**HUDSON RIVER PCBs REASSESSMENT RI/FS
RESPONSIVENESS SUMMARY FOR
VOLUME 2C-A LOW RESOLUTION SEDIMENT CORING REPORT
ADDENDUM TO THE DATA EVALUATION AND INTERPRETATION REPORT**

FEBRUARY 1999

**U.S. Environmental Protection Agency
Region II
and
U.S. Army Corps of Engineers
Kansas City District**

**TAMS Consultants, Inc.
TetraTech, Inc.**

Figure 2-4 (corrected)
Distribution of Total PCB Concentrations in Low Resolution Sediment Core Samples

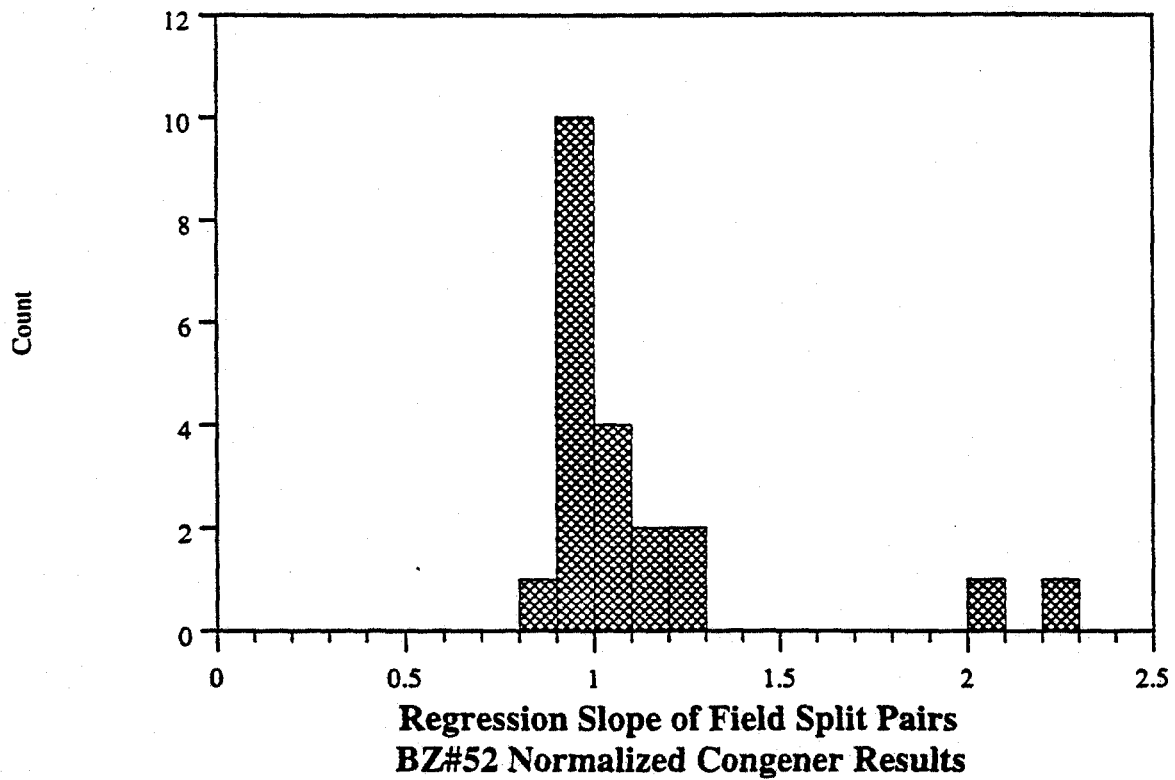
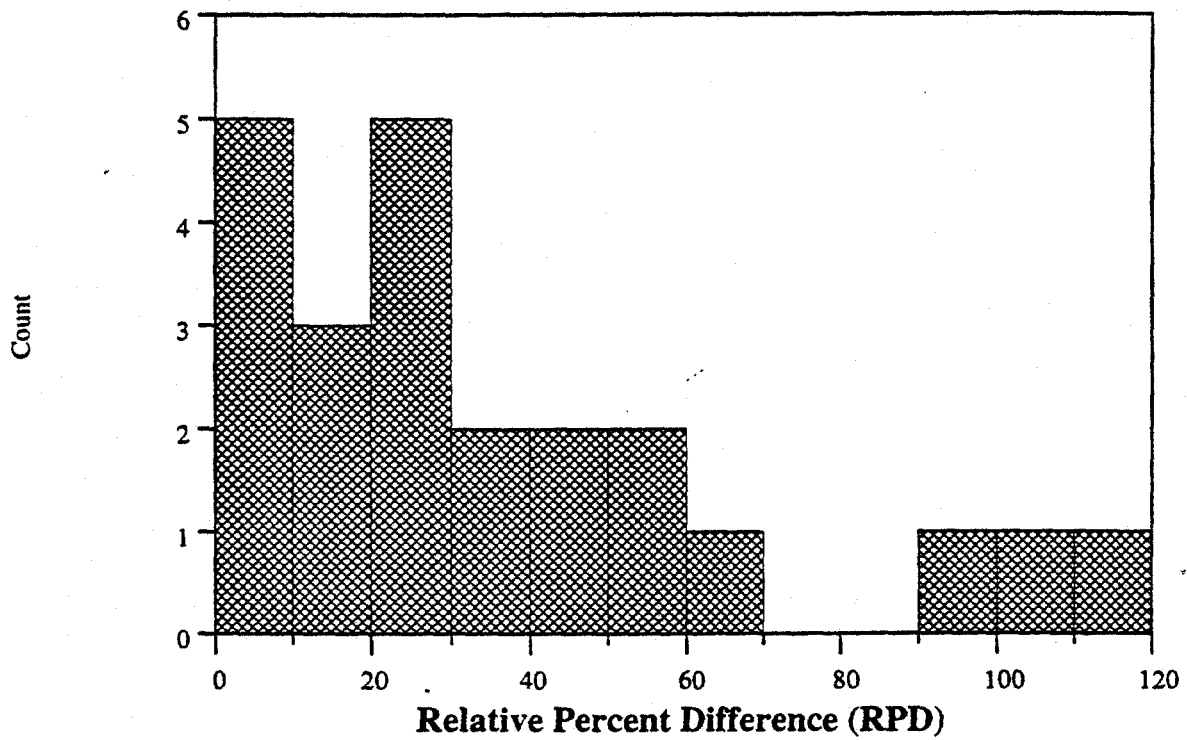
Figure 2-6 is incorrectly referenced as Figure 2-4 on page 2-18. The text of the second full paragraph on page 2-18 should read:

The units on Figure 2-4 were corrected to read mg/kg in the revised figure. The values of the abscissa of the upper figure in Figure 2-6 are corrected in the revised Figure 2-6, included in this Report.

Figure 2.4.1A
Relationship Between RPD and Total PCB Concentration for Low Resolution Core Field Splits

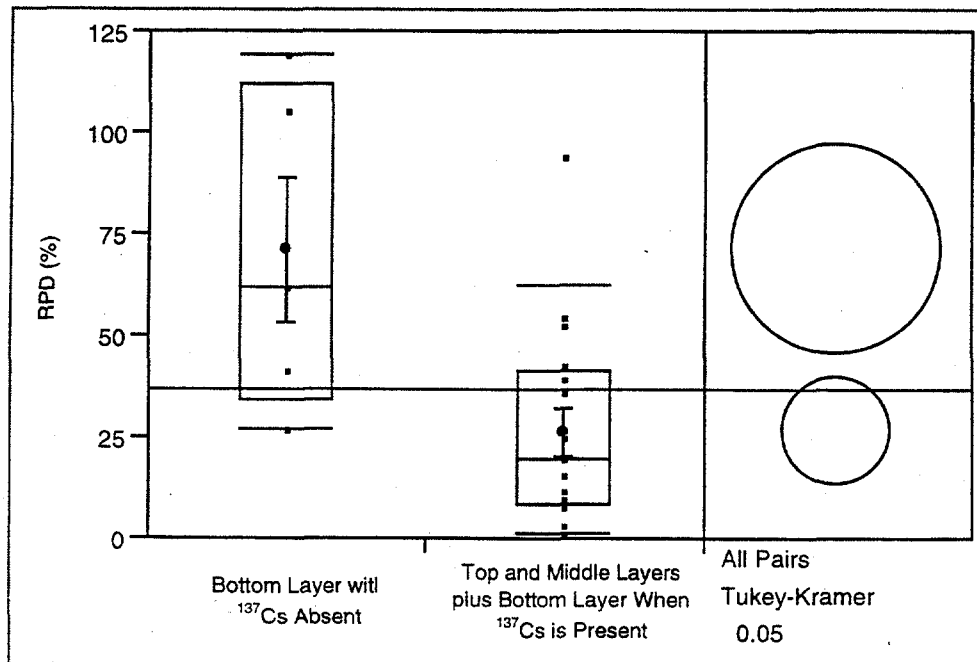
detection limit. Figure 2.4.1A shows the relationship between RPD and Total PCB concentration for the low resolution sediment coring program. The figure demonstrates the tendency of lower RPD levels corresponding to higher Total PCB concentrations. This trend, while statistically significant, is not a very strong one and much of the variation in the RPD is unrelated to concentration. The results indicate that PCB concentrations greater than 20,000 $\mu\text{g}/\text{kg}$ (20 ppm) have a mean RPD of 28 percent while those higher than 50,000 $\mu\text{g}/\text{kg}$ (50 ppm) have a mean RPD of 17 percent.

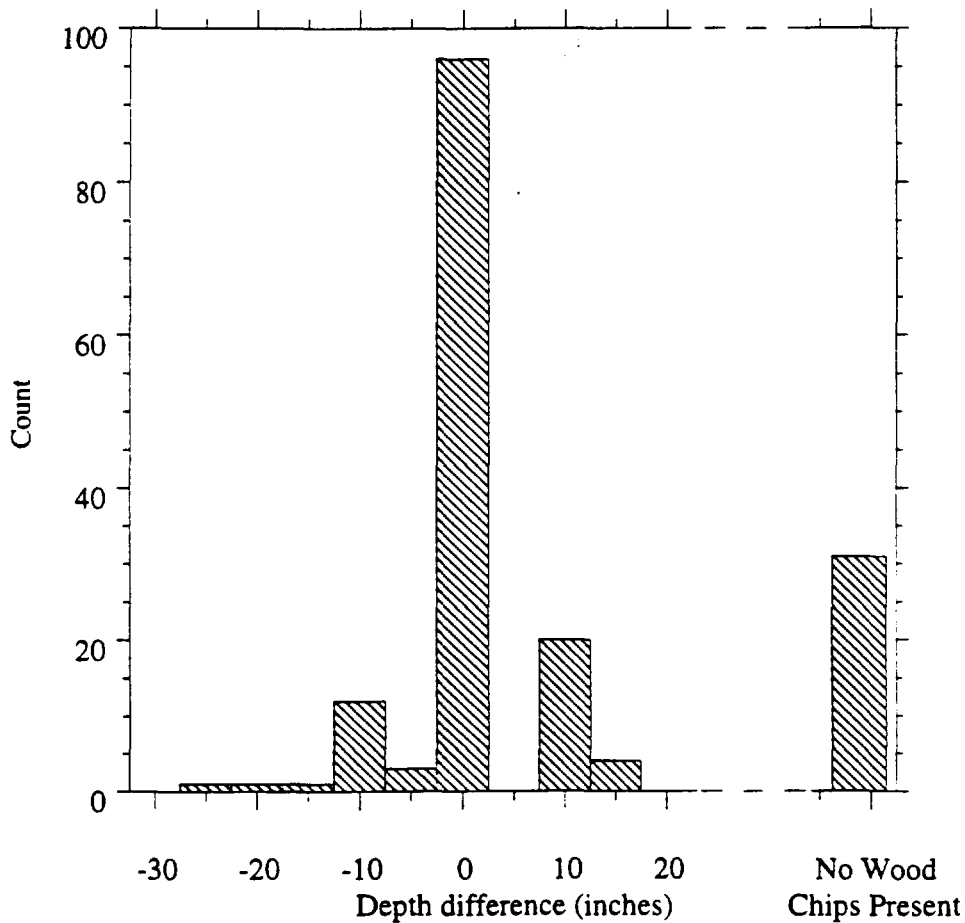
In response to this comment USEPA has prepared a further analysis of the wood chip and PCB data available for the low resolution cores. The field geologist's descriptions concerning the absence or presence of wood chips were retrieved from the database and correlated with the occurrence of the PCB maximum. This was accomplished by subtracting the upper depth of the core segment containing the PCB maximum from the upper depth of the first core segment found to contain wood chips. Thus core segments with coincident wood chips and PCB maxima were assigned a value of zero. If the PCB maximum overlay the wood chip occurrence, a negative value was obtained. If the converse was true, a positive value was obtained. The results for all low resolution cores are presented in Figure LF-1.3A. It is clear from this figure that the PCB maximum and the appearance of wood chips are coincident (difference equal to 0) in the majority of the low resolution cores, given their coarse resolution. The next largest group is those cores where wood chips were not reported. The next most important groups are those occurring at about 10 inches separation, close to the typical slice thickness. However, these non-zero difference cores scatter relatively equally about the value of 0, indicating no definitive trend. These results are consistent with the conclusion based on the C/N ratio in the LRC, that is, woody materials are present throughout Upper Hudson sediments and do not reliably predict the C/N ratio.

Figure LF-1.3C
 Total PCBs and the C/N ratio in High Resolution Cores from the Upper Hudson

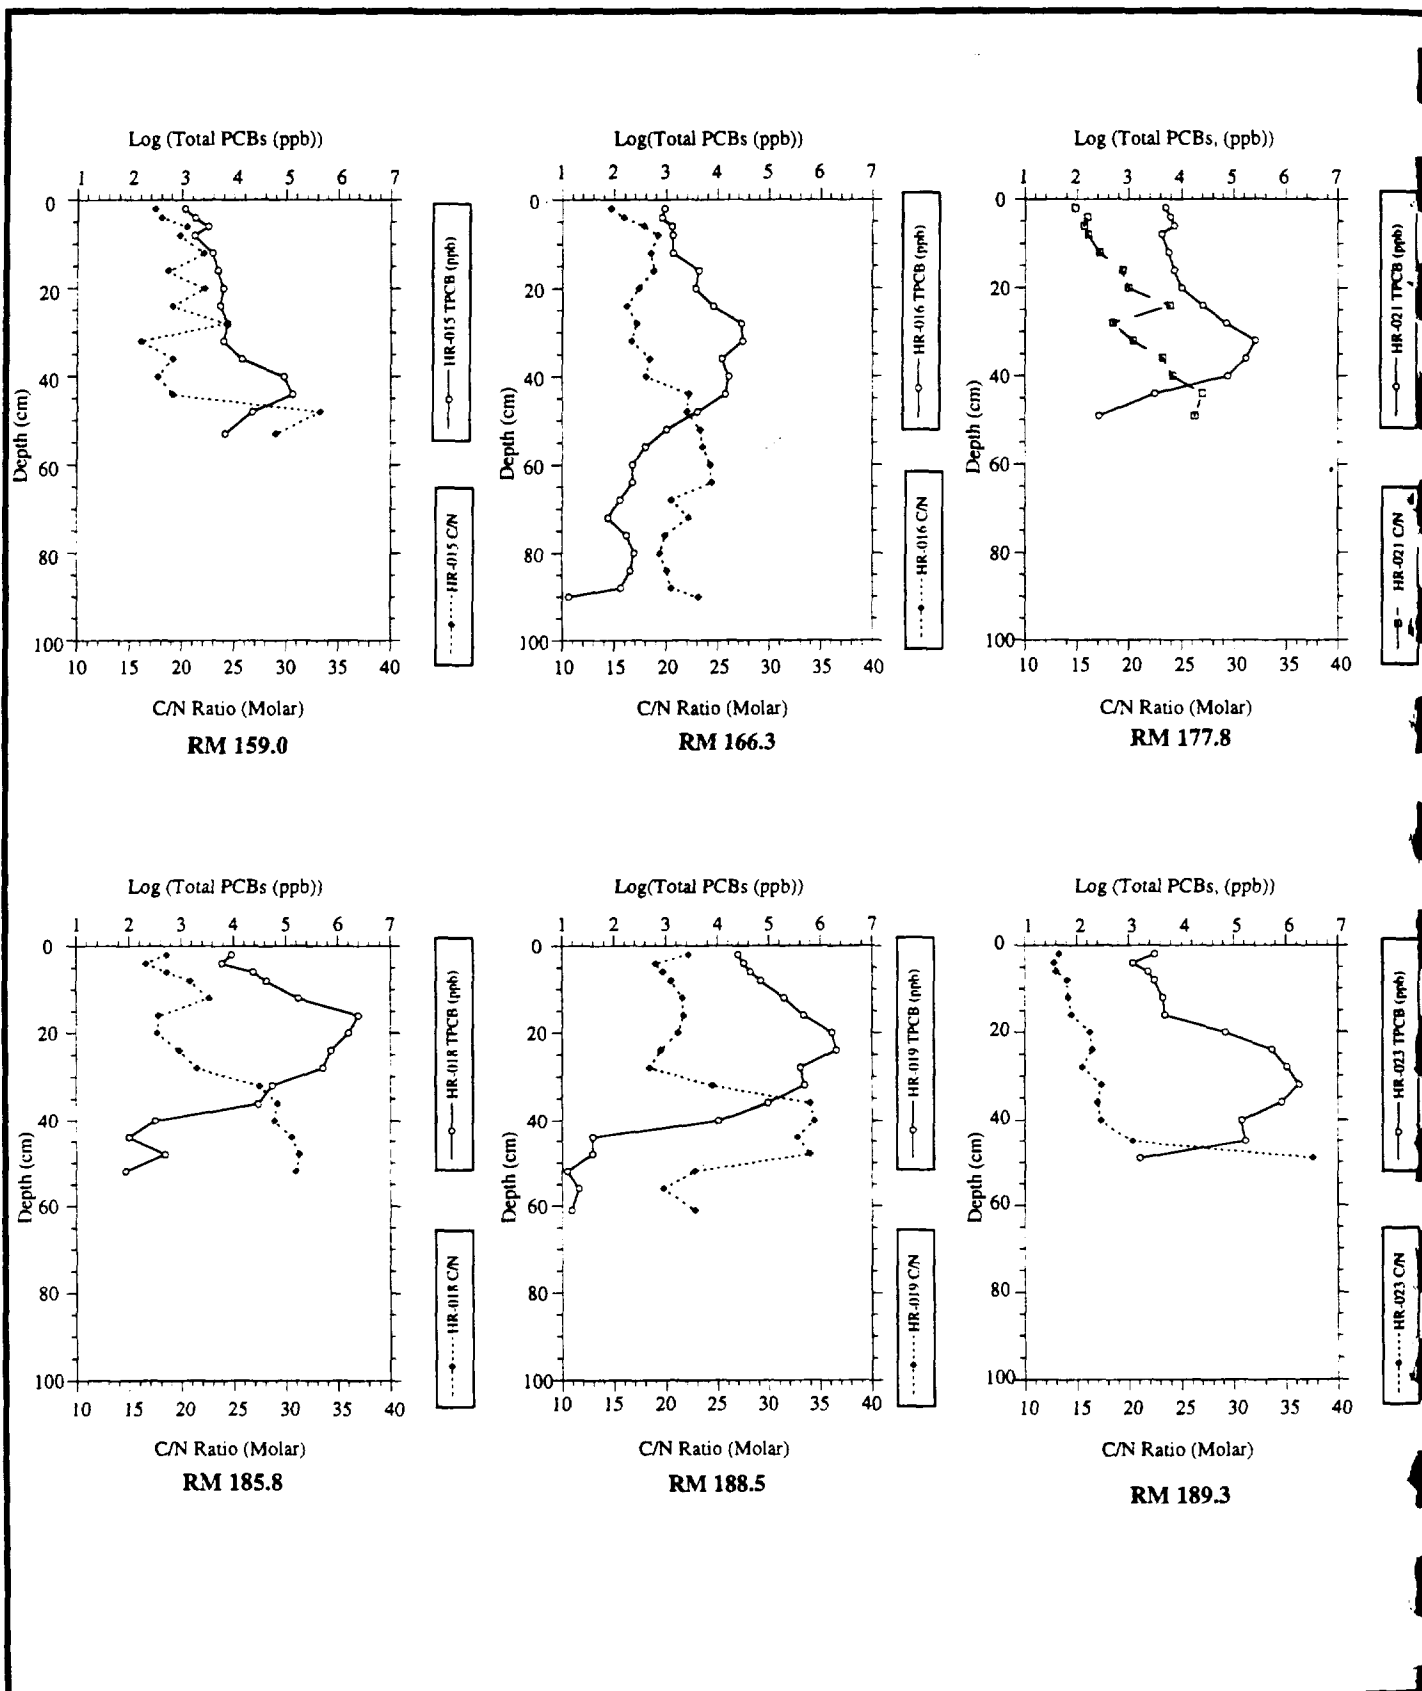
As a last analysis, the C/N ratio was examined for the high resolution cores along with the total PCB levels. These results are shown for six cores in Figure LF-1.3C. These profiles show that the C/N maximum predates the PCB maximum in every case, indicating that the ratio is not a good predictor for Total PCBs. The results also show that major wood chip releases occurred prior to the onset of GE operations, probably commensurate with wood processing operations in the early part of this century.

Figure LG-1.26A
The Relationship Between the Number of Chlorines per Biphenyl
and the Molar Dechlorination Product Ratio for the High Resolution Core Data

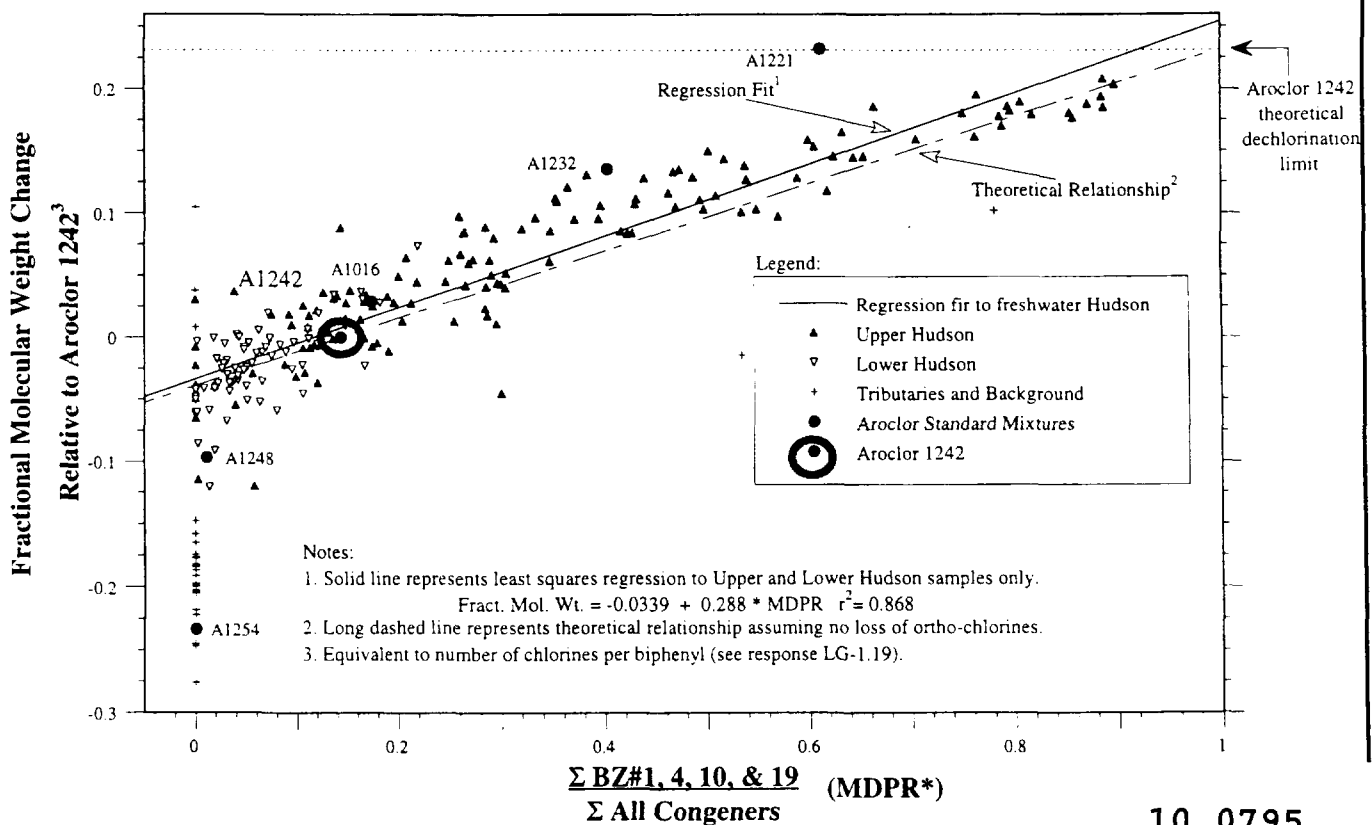
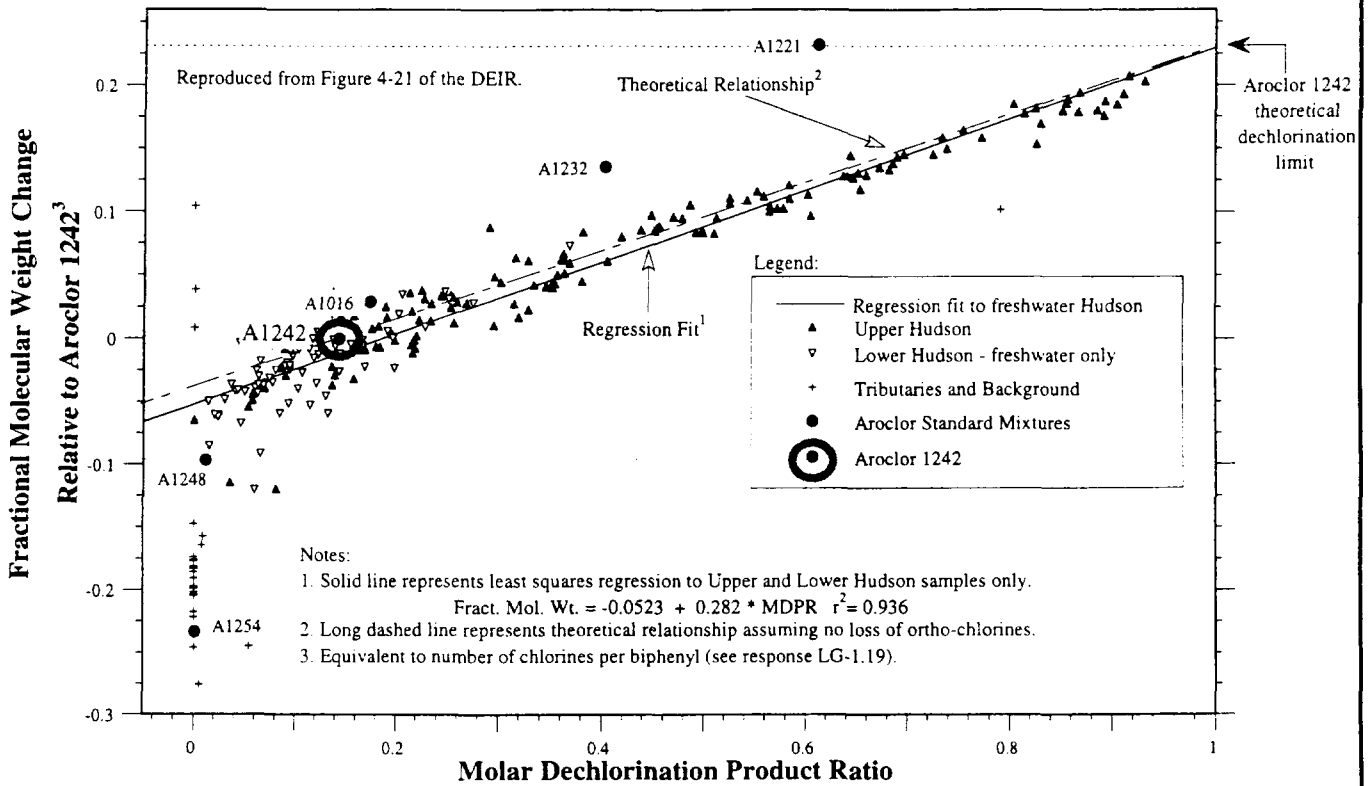
It has been demonstrated that the change in molecular weight (ΔMW) is algebraically related to the number of chlorines per biphenyl (Cl/BP) (*see* response DG-1.19 of the Responsiveness Summary for Volumes 2A, 2B and 2C). It has also been shown in both the DEIR and the LRC that the relationship between the ΔMW and the molar dechlorination product ratio (MDPR) is linear ($R^2 = 0.90$ or higher), meaning that the dechlorination products are produced in direct proportion to the degree of chlorine mass loss from a sediment mixture. Therefore, since these measures track each other and are directly related to Cl/BP, they directly reflect the degree of dechlorination in a sample. The quality of these measures can be contrasted with the relationship between Cl/BP and the ratios proposed by GE. This is illustrated by comparing Figure LG-1.21 and Figure LG-1.26A. The ratios proposed by the writer yield R^2 values of 0.4 or less, indicating the substantially greater scatter and therefore reduced sensitivity in these relationships. In particular note the broad ratio ranges seen around 2.5 to 3 Cl/BP, levels commonly found in the Hudson.

The discussion concerning the insensitivity of the MDPR to the conversion of BZ#8 (2,4'-dichlorobiphenyl) to BZ#1 is misleading. This conversion is only important at extremely high degrees of dechlorination. At levels more typical of Hudson sediments, BZ#8 forms an important intermediate whose inclusion in the MDPR enhances the usefulness of this ratio. This is illustrated in Figure LG-1.26B which compares the MDPR and MDPR*. MDPR* is defined as the sum of BZ#1, 4, 10 and 19 (excluding BZ#8) over the sum of all congeners on a molar basis. Figure LG-1.26B shows that the MDPR* also tracks the change in molecular weight although not as well as the original MDPR. However, both ratios are clearly superior to the ratios proposed by the writer.

Figure 4-2 (corrected)
High Resolution Core 19 from the TI Pool

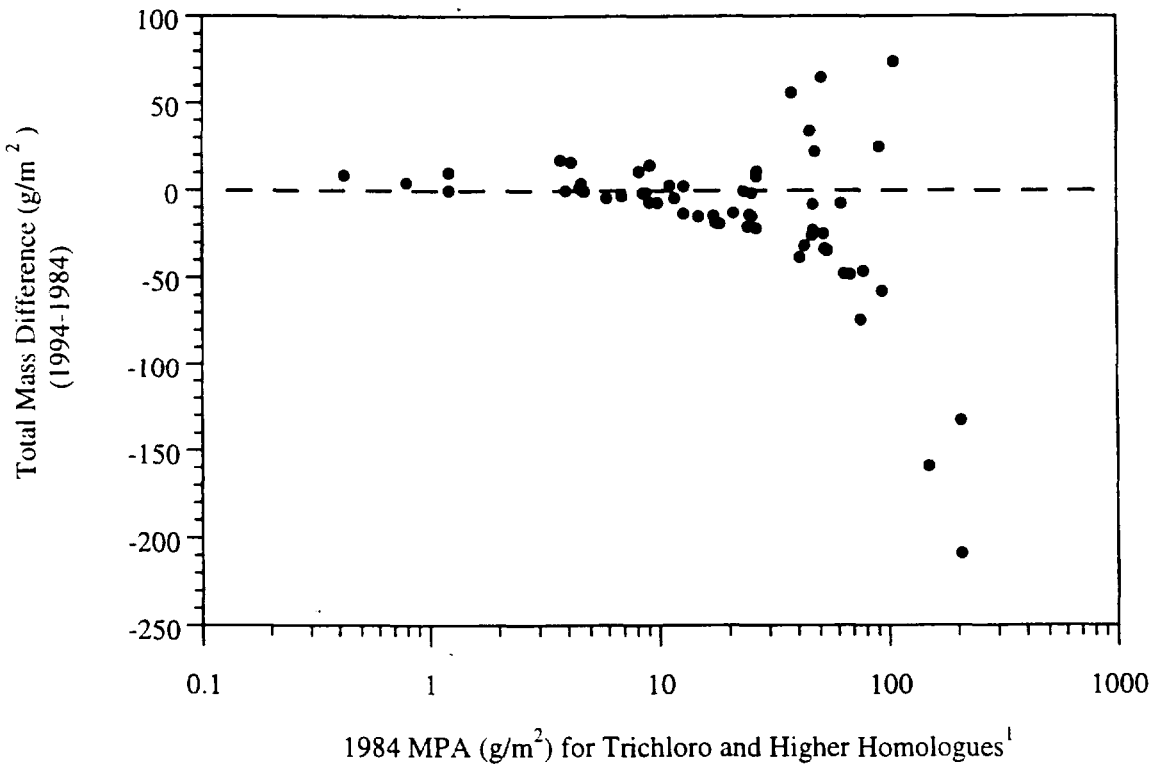
Figure 4-2 has been revised to show the correct units of depth.

Figure 4-7 (corrected)
1984 Trichloro and Higher Homologues as MPA vs
Mass Difference Relative to 1994 - Log Scale

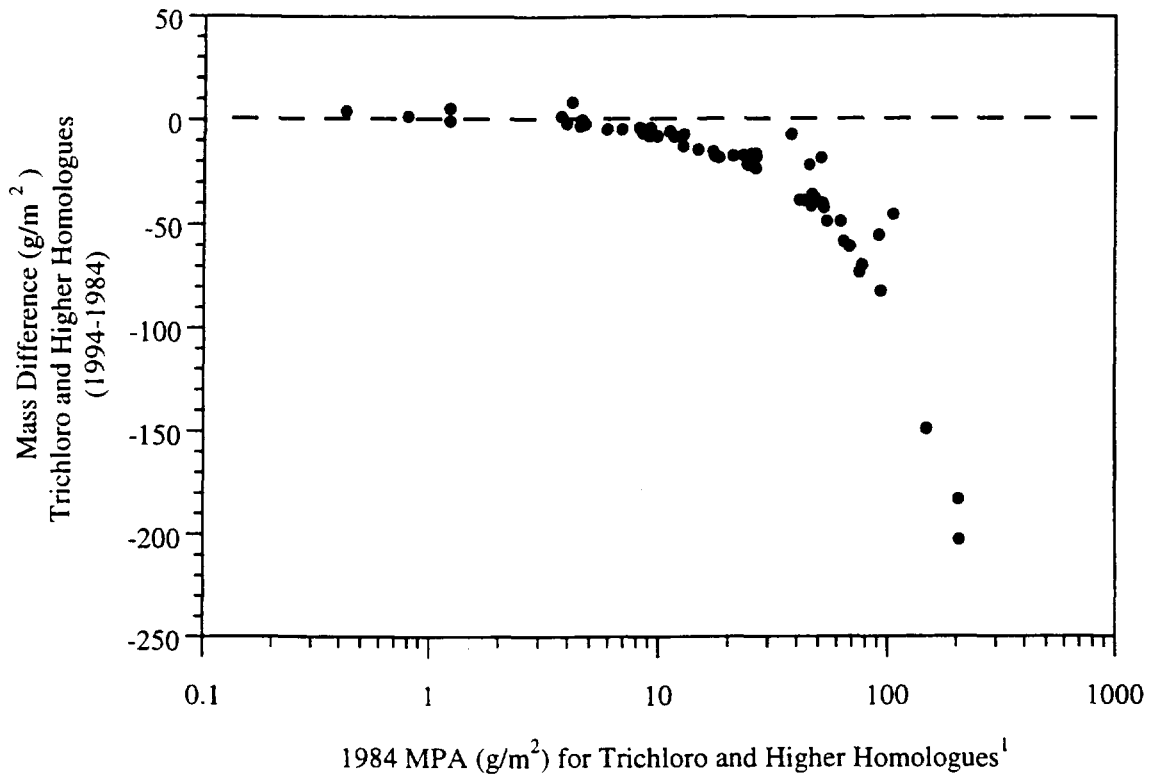
Figure 4-7 has been revised. The graphs are reversed to match the discussion in the text and the units have been corrected.
